MILITARY SPECIFICATION

SEMICONDUCTOR DEVICE, TRANSISTOR, PNP, GERMANIUM
TYPE 2N695

This amendment forms a part of MIL-S-19500/135A(NAVY), dated 18 December 1968, and is approved for use within the Space and Naval Warfare Systems Command, Department of the Navy and is available for use by all Departments and Agencies of the Department of Defense.

FIGURE 1. Physical dimensions. "

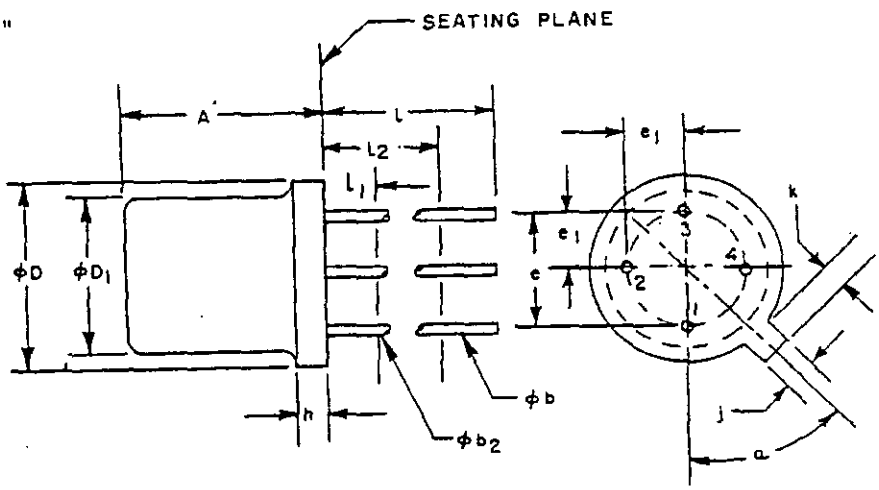
FIGURE 1, delete and substitute:

NOTES:
1. Metric equivalents are given for general information only.
2. (Four leads). Maximum number of leads omitted in this outline, "none" (0). The number and position of leads actually present are indicated in the product registration. Outline designation determined by the location and minimum angular or linear spacing of any two adjacent leads.

3. (All leads) ϕb_2 applies between L_1 and L_2. ϕb applies between L_2 and .500 inch (12.70 mm) from seating plane. Diameter is uncontrolled in L_1 and beyond .500 inch (12.70 mm) from seating plane.

4. Measured from maximum diameter of the product.
5. Leads having maximum diameter .019 inch (0.438 mm) measured in gauging plane .054 inch (1.37 mm) +.001 inch (0.025 mm) - .000 inch (0.000 mm) below the seating plane of the product shall be within .007 inch (0.178 mm) of their true position relative to a maximum width tab.

6. The product may be measured by direct methods or by gauge.
7. Tab centerline.
